Harris Nuclear Plant Pre-Submittal Meeting - February 27, 2018

License Amendment Request for
Emergency Plan Emergency Action Level
Scheme Changes

III. Cold Shutdown Radiation Monitor Threshold

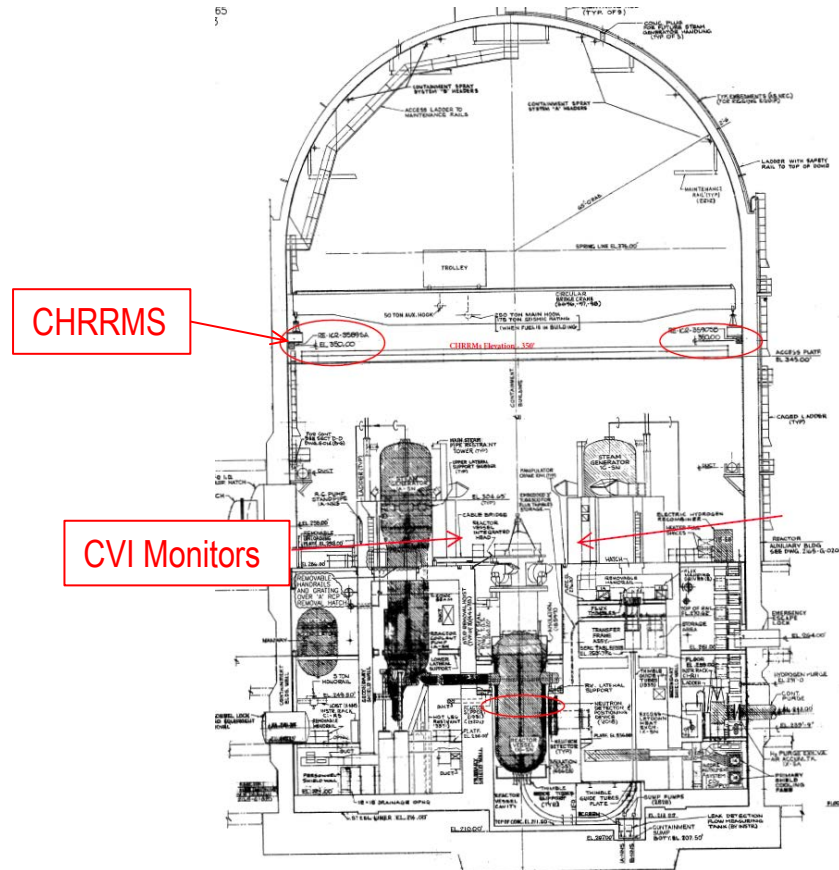
Current: 'CG1.2' and 'CS1.3' utilize CNMT radiation levels at the CHRRMs

Proposed: Utilize Containment Ventilation Isolation (CVI) radiation monitors high alarm

A CVI monitor in high alarm (RM-1CR-3561A-SA, RM-1CR-3561B-SB, RM-1CR-3561C-SA, or RM-1CR-3561D-SB)

CVIs offer several advantages over CHRRMs for use in EALs CS1.3 and CG1.2:

- Better low range sensitivity
- Greater number of monitors
- Closer to the core
